# **DORROUGH ELECTRONICS**

## POWER SUPPLY UPDATE SHEET FOR THE DISCRIMINATE AUDIO PROCESSOR

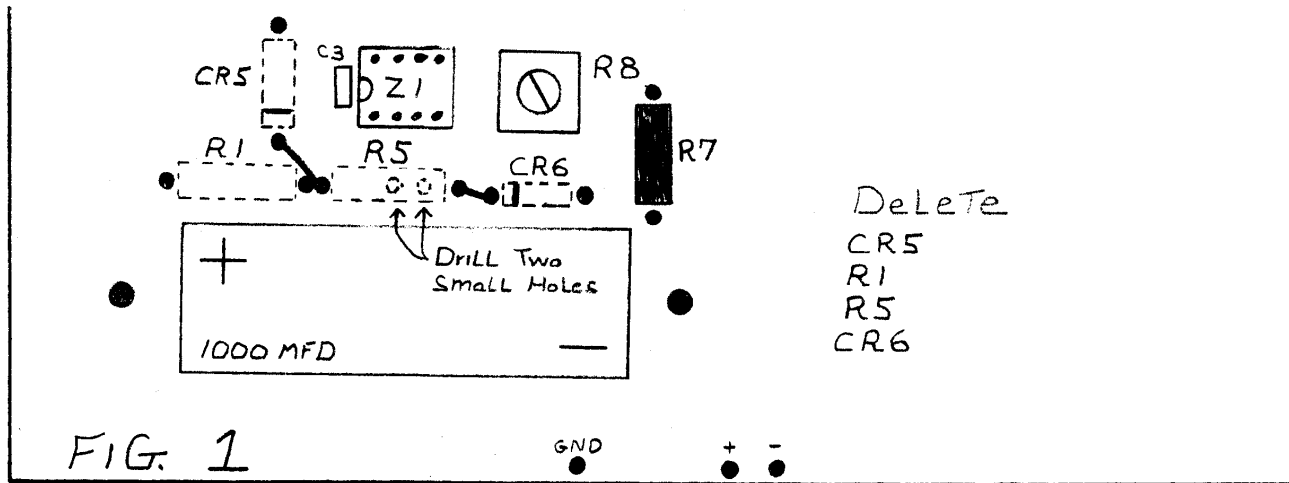
Briefly the Opamp Z1 compares the inverting input to a reference voltage on the non-inverting input. This reference voltage in all systems prior to serial number 021223 was obtained using R1, R5, CR5, and CR6.

With a three pin voltage regulator this circuit was upgraded to provide a more stable voltage reference source. The new device, a National Semiconductor #LM342-10, can be easily installed and tested.

Remove the old reference components by lifting the power supply and unsoldering components R1, R5, CR5, and CR6.

Drill two small holes approximately 2/16 inches in diameter in line with the old junction of R5 and CR6 (see Fig. 1) approximately 1/8 inch center to center.

Install the device with the chamfer on the face towards C1 (see Fig. 2). This is important as it orients the pins for correct assembly.

Note: The pin below the chamfer is the regulator output. It should go into the hole vacated by R5 at the R5, CR6 junction. If incorrect assembly occurs, the power supply will not be damaged.

1. Using black 24 AWG insulated buss wire, jumper the center pin to the negative side of C1.

2. Using red 24 AWG insulated buss wire, jumper the pin closest to the front of the DAP to the plus side of C1.
3. Solder the pin on the chamfered side to the old R5, CR6 pad (leading to Z1 pin 3).
